Re: Castle Valley Mining LLC
Castle Valley Mines
NOV- 10068 Abatement
Permit No. C/015/0025

On behalf of Castle Valley Mining, LLC, attached is an application for a permit change to comply with the abatement actions required by NOV-10068 issued on September 22, 2010.

APPLICATION FOR COAL PERMIT PROCESSING
Detailed Schedule Of Changes to the Mining And Reclamation Plan

C/015/0025Title: NOV-10068 Abatement

Figure 7-15 Ditch D-8D Water Bar Concrete Structure*

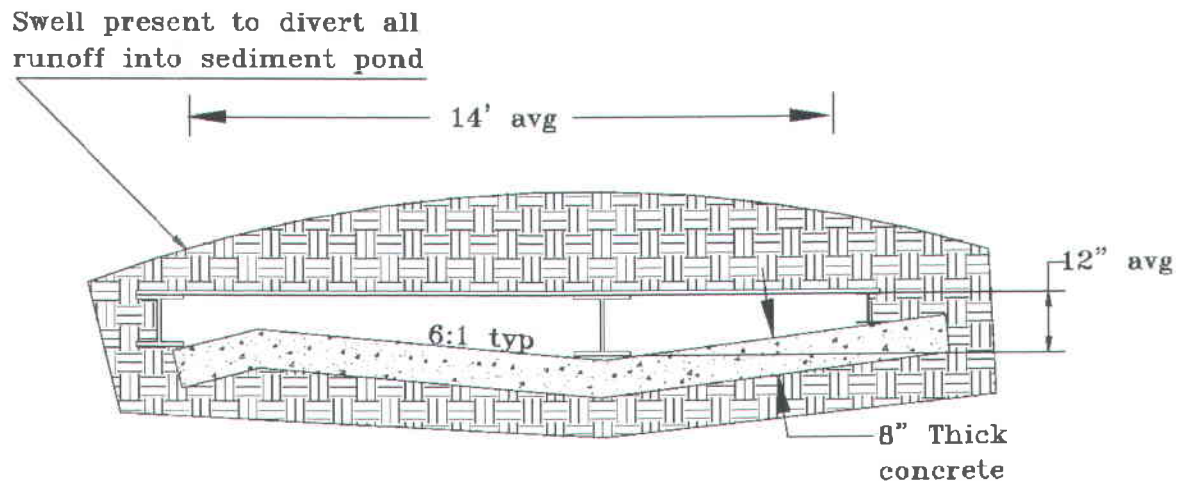
During October of 2010 as part of a response to NOV-10068, it was discovered that the Ditch D-8D water bar was never constructed, and therefore, references to it on applicable Plates and Permit text have been removed.

*Water bar was never constructed.
